Addendum #2 Construction Manager as Constructer Services Hangar 2003 Renovations Fort Wayne International Airport

Issued: August 21, 2025

Attachment J

Original Building Drawings

OPTION B

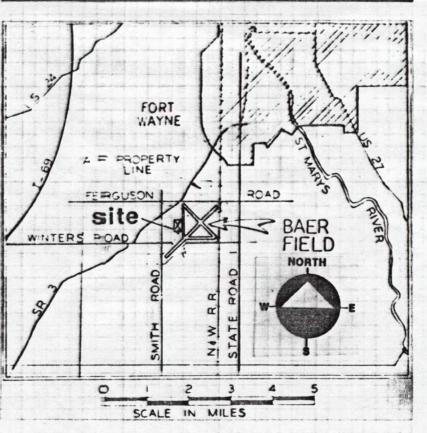
- > 8/26/25 11am-12noon
- > 8/28/25 3pm-4pm
- > 9/3/25 11am-12noon
- > 9/4/25 1pm-2pm
- 9/8/25 1pm-2pm
- Attachment I, Schematic Architectural Site Plan Drawing is included with this addendum and added to the Scope of Work as follows:

B, Option B
